Safety Evaluation Report

Related to Renewal of the Facility Operating License
for the University of Massachusetts Lowell Research
Reactor

License No. R-125
Docket No. 50-223

U.S. Nuclear Regulatory Commission

Figure 2-10 PLTEMP Power-to-Flow Map at ONB

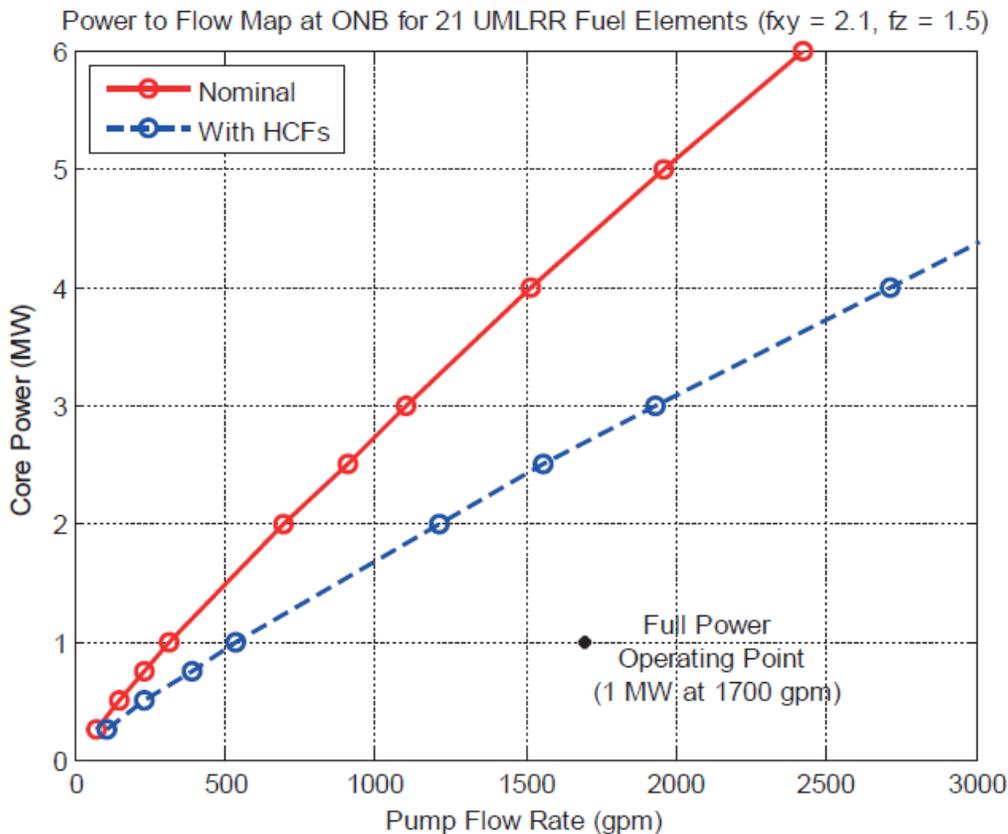
UML's PLTEMP power-to-flow map is shown in SER Figure 2-10 (taken from SAR Figure 4-17). The power-to-flow map identifies, for a given power level, what total pump flow rate would lead to ONB conditions in the hot channel. The map illustrates that at nominal power and flow conditions, or LSSS power and flow conditions, there is a large margin to ONB (regardless of whether hot channel factors are conservatively applied). All calculations for the map conservatively assume a pool inlet temperature of 110 °F (43.3 °C), slightly above the LSSS setpoint.

Figure 2-11 Case 1 Axial Temperature Profiles

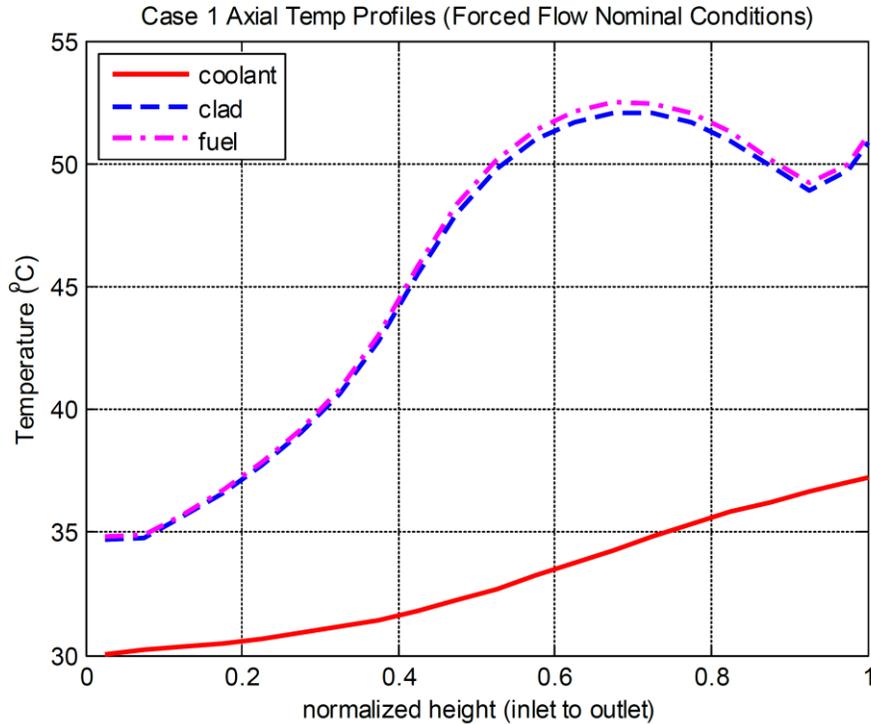
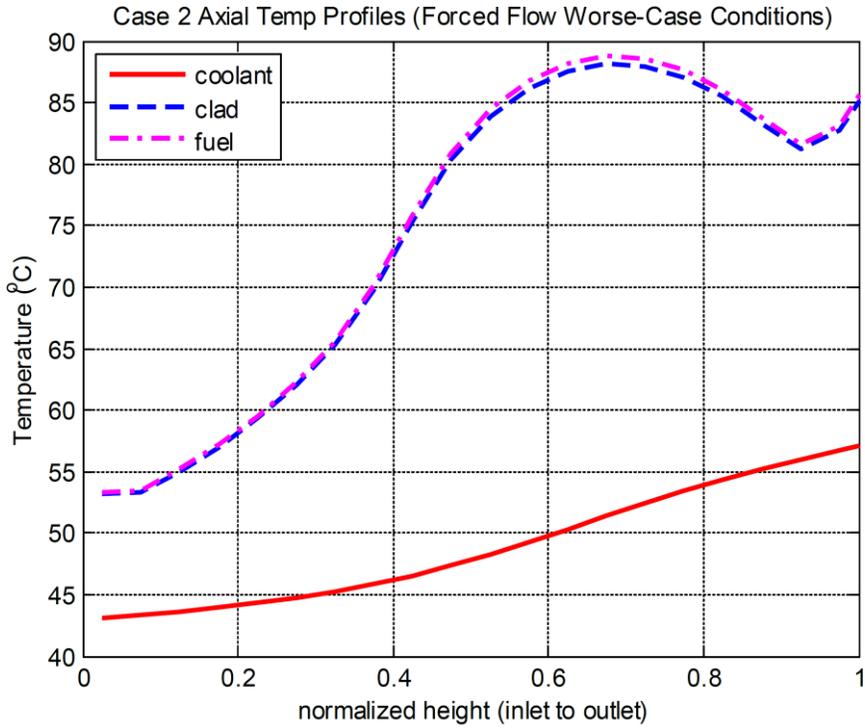
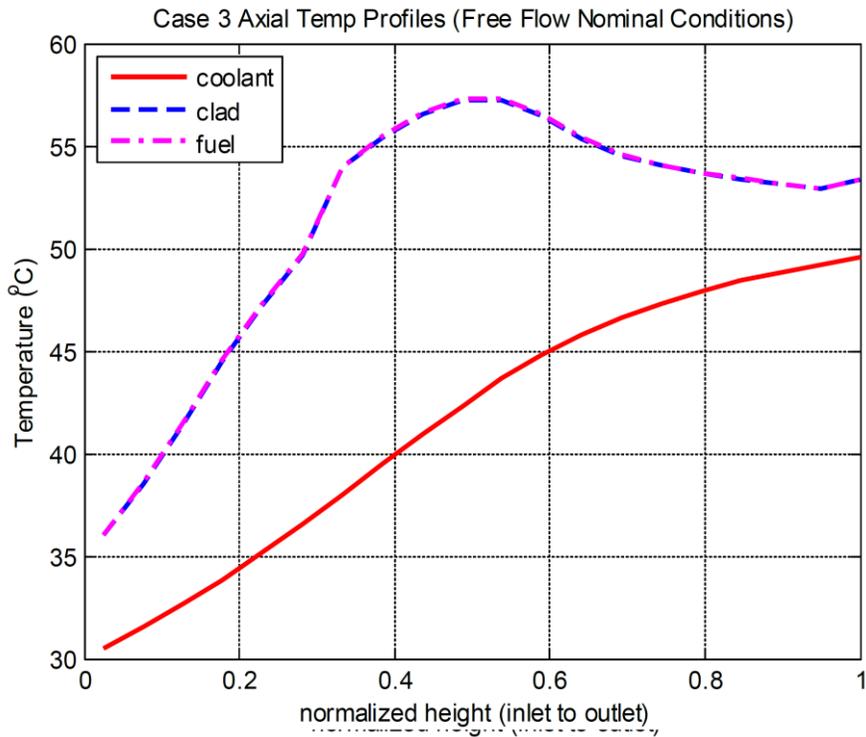
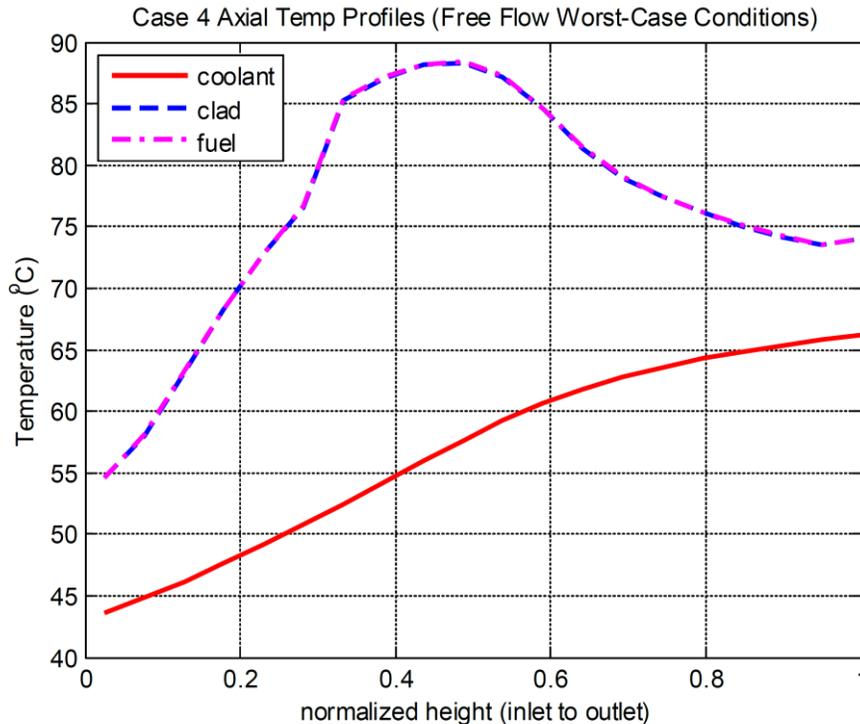
The above axial temperature profiles indicate that for steady-state UMLRR operation, at nominal or beyond-LSSS conditions, the fuel and cladding temperatures remain well below both the TS 2.1 SL and the minimum ONB threshold of 118 °C (244 °F), confirming a large margin to ONB or possible fuel failure for any routine condition of forced flow or natural convection operation.

Figure 5-1 Step Insertion of 0.6% $\Delta k/k$ for Forced Flow and Initial Power of 0.01 Watt-thermal

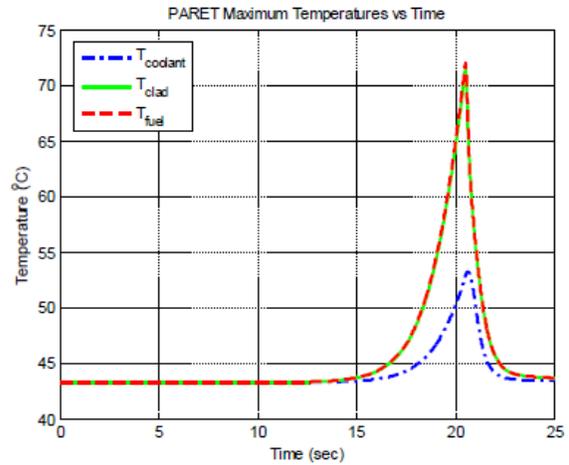
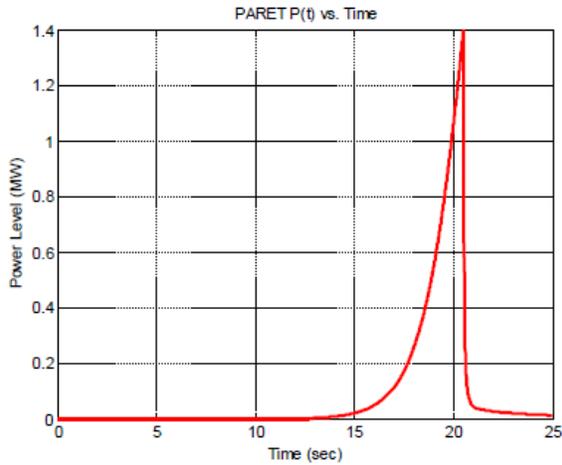
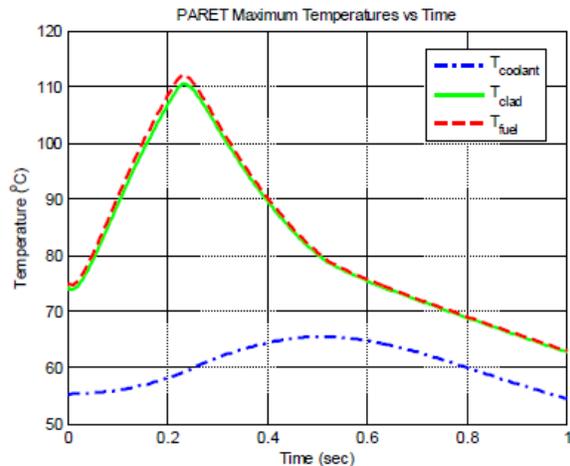
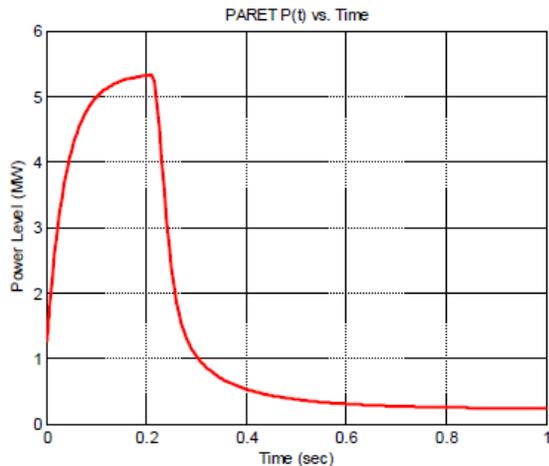
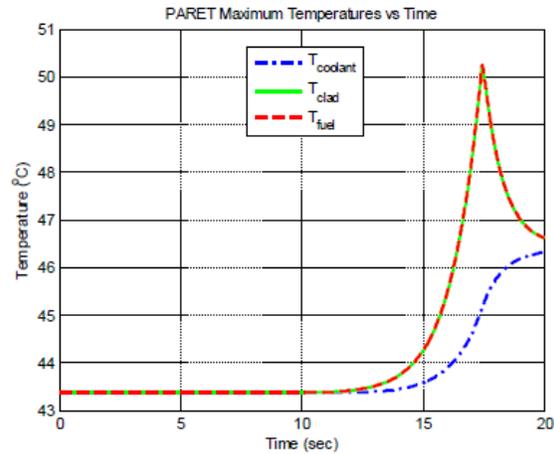
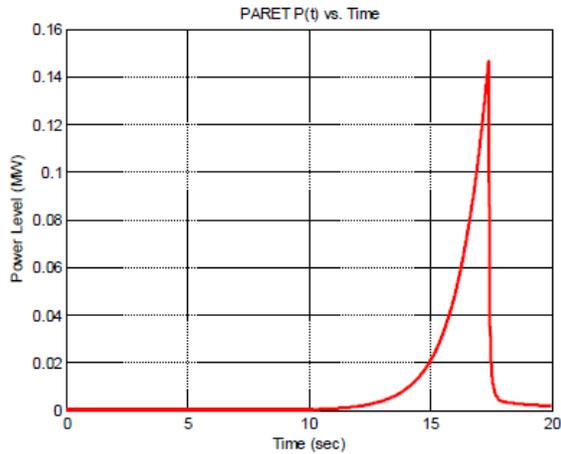
The figures show that for all four scenarios, the maximum fuel cladding temperature remains below the minimum onset of nucleate boiling (ONB) threshold of 118 °C (244 °F) and well below the TS 2.1 safety limit (SL) of 530 °C (986 °F). UML stated that its analyses show that ONB does not occur for any of its step insertion scenarios. In the worst-case step insertion scenario, for forced flow operation and initial reactor power of 1.25 MWt (SER Figure 5-2), the maximum cladding temperature reached is approximately 111 °C (232 °F) and the maximum reactor power level reached is approximately 5.3 MWt.

Figure 5-5 Ramp Insertion of 0.07% $\Delta k/k$ per second for Forced Flow and Initial Power of 0.01 Watt-thermal

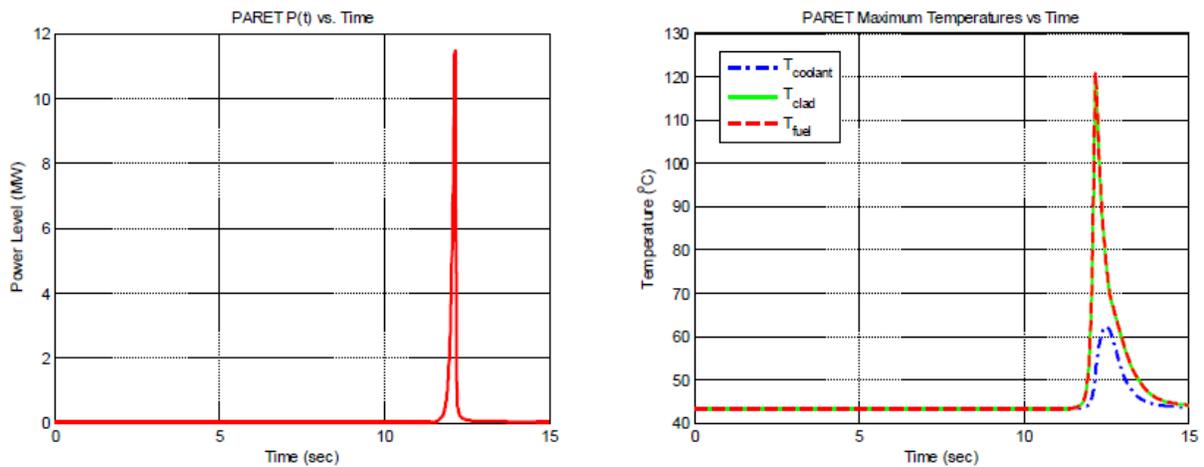
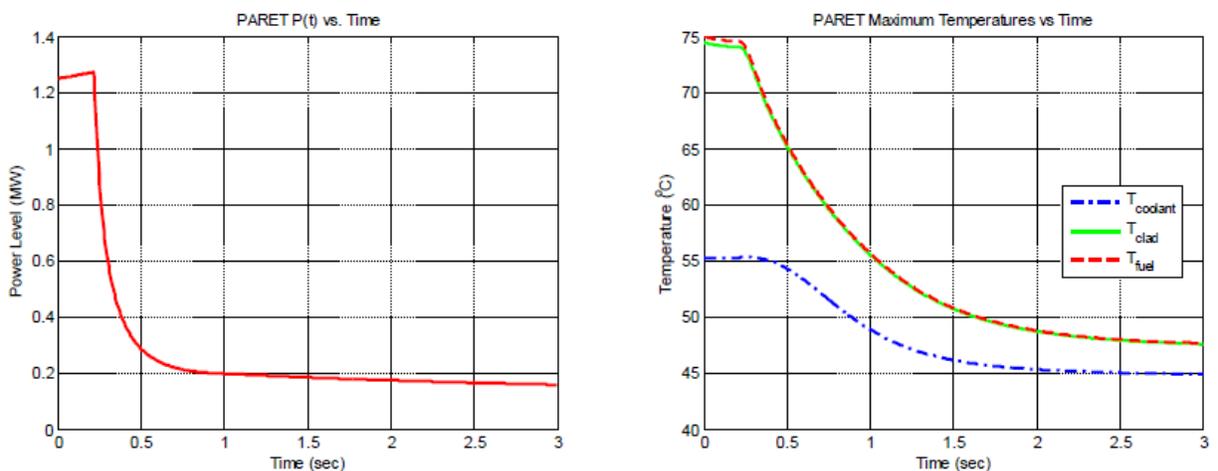
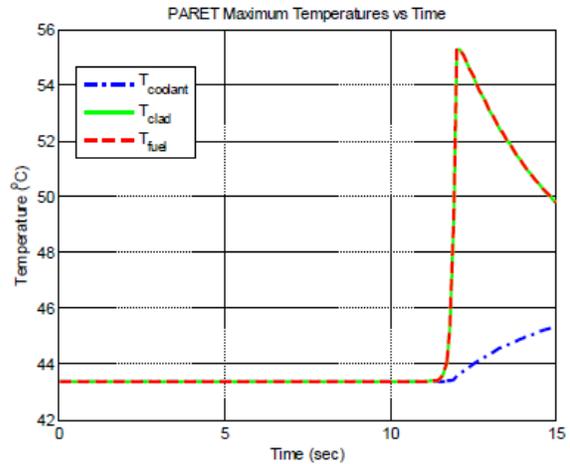
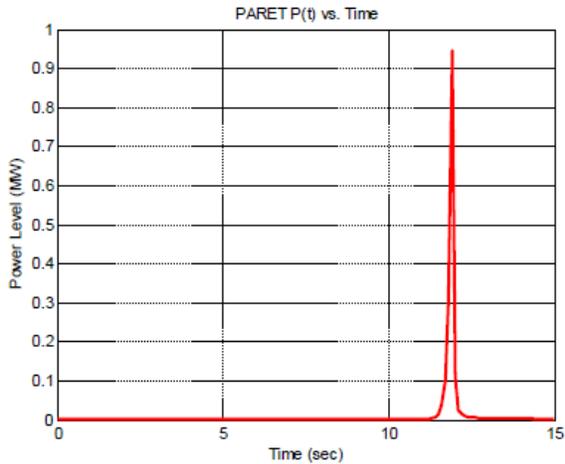
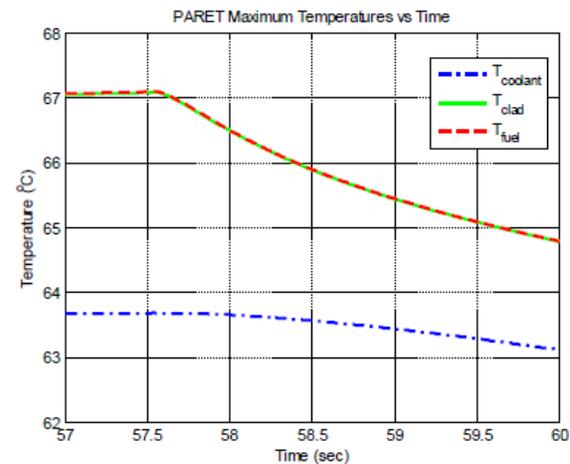
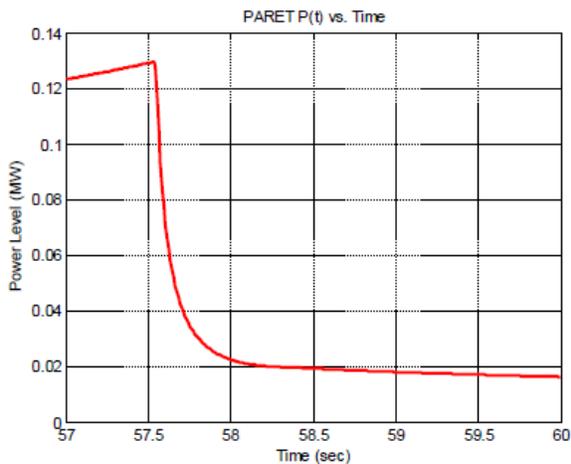
The figures show that for all ramp insertion scenarios except for the forced flow mode operation with initial reactor power of 0.01 watt-thermal scenario, which is the worst-case scenario and which is illustrated in SER Figure 5-5, the maximum fuel cladding temperature remains well below the TS 2.1 SL and the minimum ONB threshold of 118 °C (244 °F). In the worst-case ramp insertion scenario, the maximum cladding temperature reached is approximately 120 °C (248 °F) and the maximum reactor power level reached is approximately 11.5 MWt. However, UML stated that its analyses for all four ramp insertion scenarios showed that ONB does not actually occur. Additionally, the figures for all four scenarios show that the maximum cladding temperature remains well below the TS 2.1 SL of 530 °C (986 °F).

Figure 5-9 NRC Staff Confirmatory Calculation of Ramp Insertion of 0.05% $\Delta k/k$ per second for Forced Flow and Initial Power of 0.01 Watt-thermal

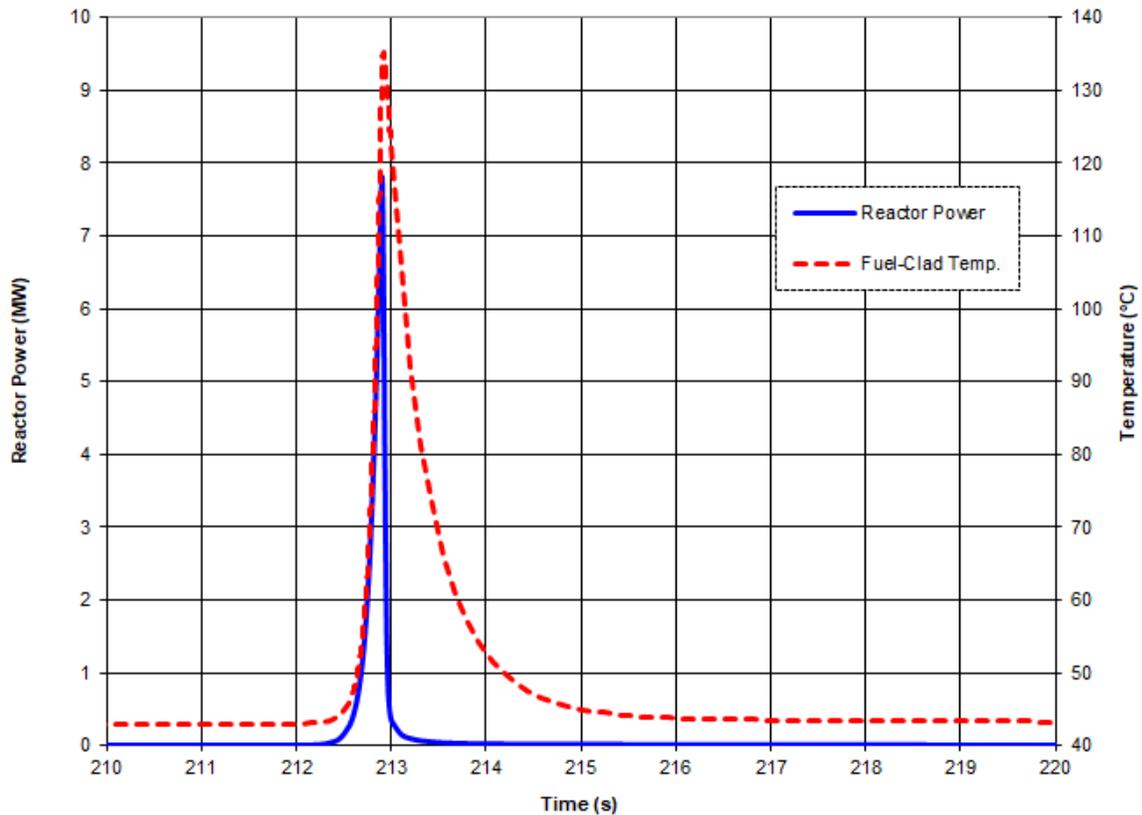
The results of the NRC staff's confirmatory calculation are shown graphically in SER Figure 5-9, which shows plots of reactor power and fuel cladding temperature versus time. For the calculation with results illustrated in Figure 5-9, the maximum cladding temperature is approximately 135 °C (275 °F) and the maximum reactor power is approximately 7.8 MWt.

Figure 5-14 Peak Fuel Cladding Temperature versus Time for NRC Staff LOCA Fuel Integrity Confirmatory Analysis

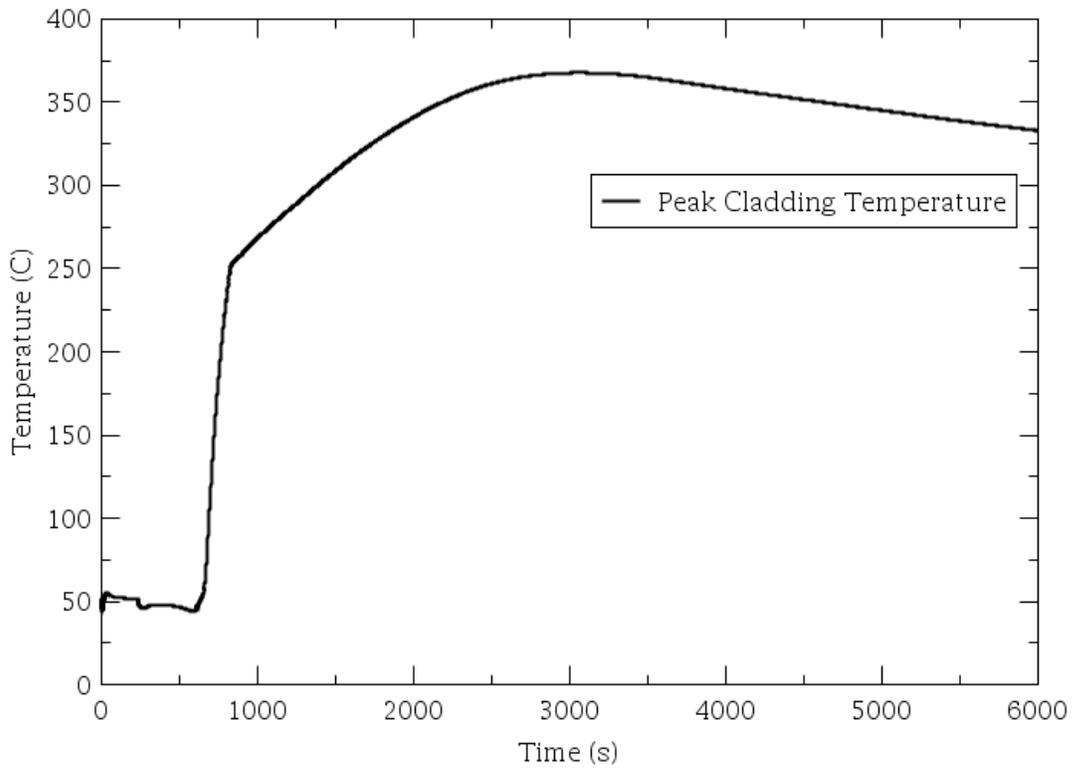
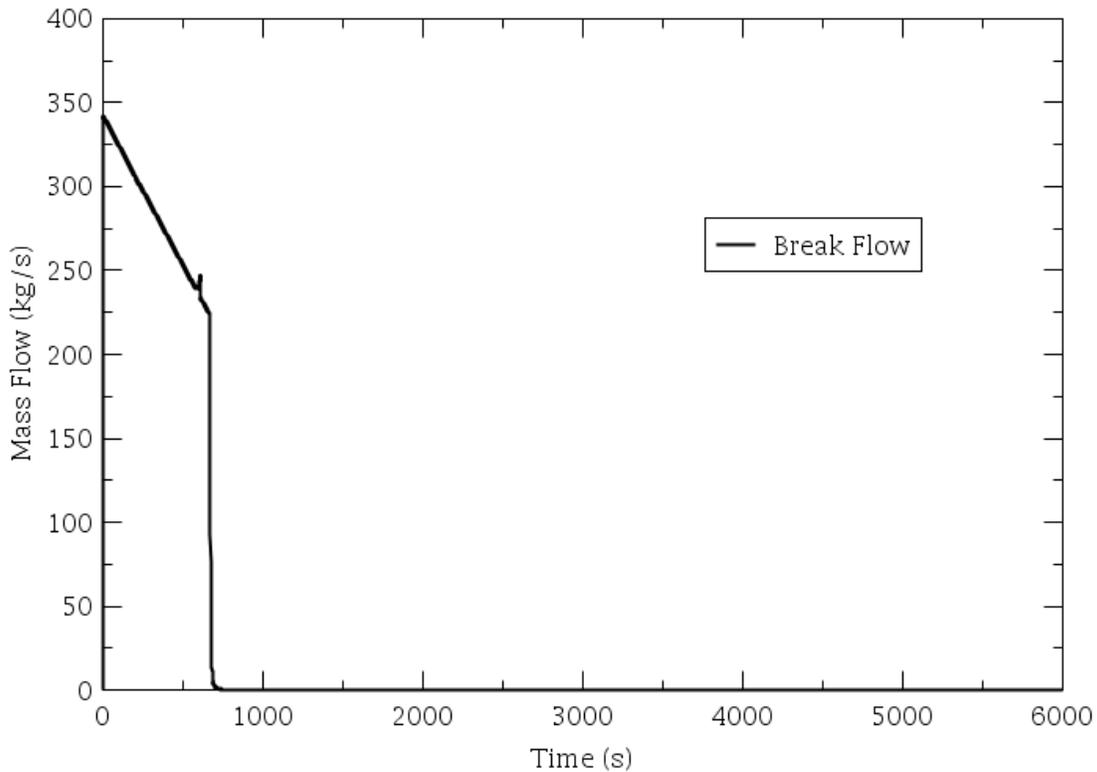
The results of the NRC staff's LOCA fuel integrity calculations are illustrated in SER Figure 5-14 and Figure 5-15 below. Figure 5-14 shows the peak cladding temperature versus time following the reactor scram. Figure 5-15 shows the mass flow rate of coolant out of the pool versus time following the reactor scram.

The NRC staff's analysis determined that, for an 8-inch diameter break, the maximum fuel cladding temperature is approximately 367.7 °C (693.9 °F), which is well below the SL and temperatures at which fuel cladding failure could occur. The pool drains much more quickly than in UML's analysis, given the larger break size. The analysis shows that the cladding temperature remains relatively low and constant while the pool is draining, then increases to a maximum after a portion of the fuel becomes exposed. For the 8-inch diameter break, the maximum temperature is reached approximately 3,038 seconds after the scram. (The NRC staff notes that, because the RINSC and UML analyses discussed above are based on a steady-state solution, they are independent of, and do not calculate, the time at which the maximum temperature occurs.)
